Addendum to the Urban Design Brief & Streetscape Analysis

***1839 Four Mile Creek Road, Town of
Niagara-on-the Lake***

August 2025

Figure 1. Stepback at the 3rd floor is proposed in the front elevation (right picture) whereas the previous design (left picture) does not incorporate stepback.

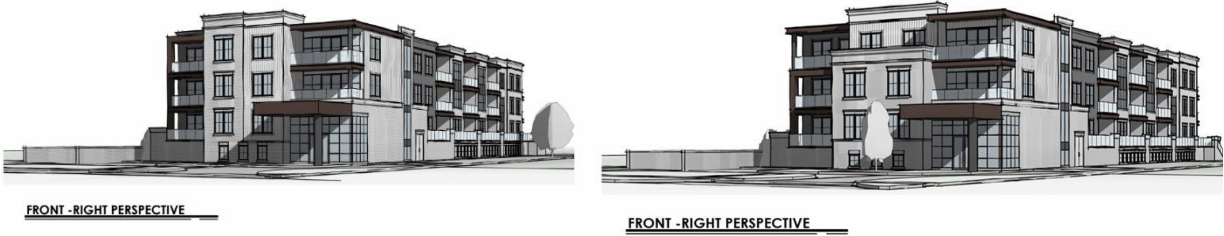
As part of the revisions, a stepback has been introduced at the 3rd Floor to further reduce perceived massing at the pedestrian level.

Figure 2. A new pedestrian exit from the parking structure to grade has been provided in the rear yard (right picture) whereas the previous design (left picture) does not have any exit at this location.

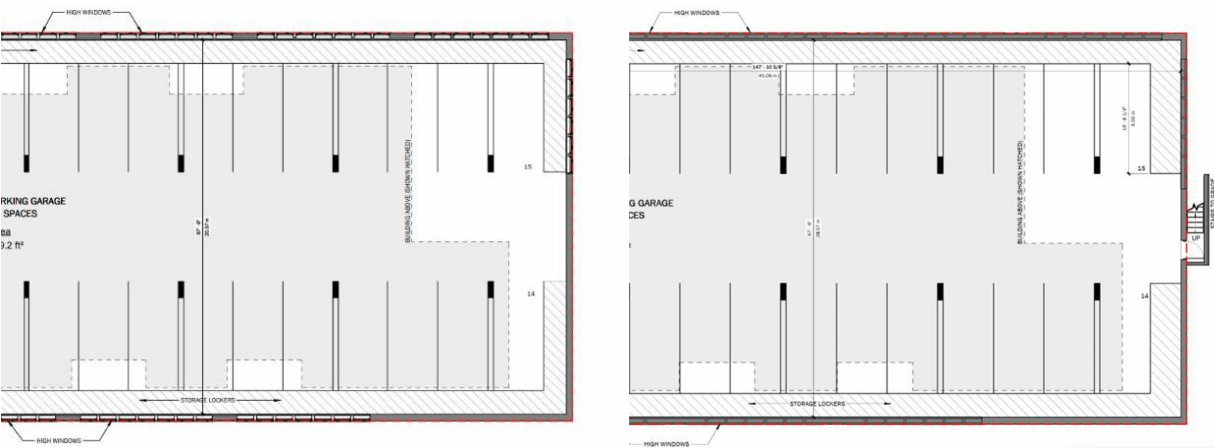
Policy 6A 4.4 b) encourages a secondary entrance at the side or back of the parking structure. Although no changes are proposed to the partially underground parking structure, a second pedestrian exit has been added at the rear through the site plan revision. Additionally, the internal drive aisle in front of the building has been reduced from a double lane to a single lane. This redesign allows for additional landscaping and fosters a more pedestrian-friendly environment, aligning with the intent of Policy 6A 4.6 g).
